STARTER MOTORS & ALTERNATORS

IMPORTANT PLEASE READ THE INFORMATION BELOW BEFORE FITTING THIS PART AS THERE ARE KNOWN ISSUES WHICH WILL RESULT IN THE PREMATURE FAILURE OF THE UNIT AND MAY INVALIDATE YOUR WARRANTY

ORIGINAL BELT ROUTING

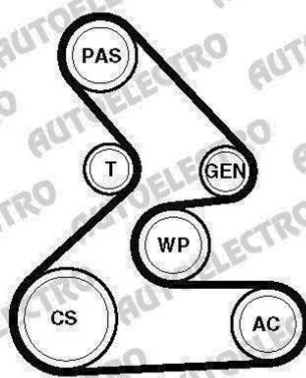
The vehicle to which this alternator is fitted has a known fault which results in the premature failure of the clutch pulley and/or bearings. The premature failure can be caused due to excessive load being exerted to the alternator pulley and bearings.

It is recommended that the belt is replaced with a **7PK1785** and a guide pulley is removed. By carrying out this modification the pressure applied to the components is reduced.

MODIFIED BELT ROUTING
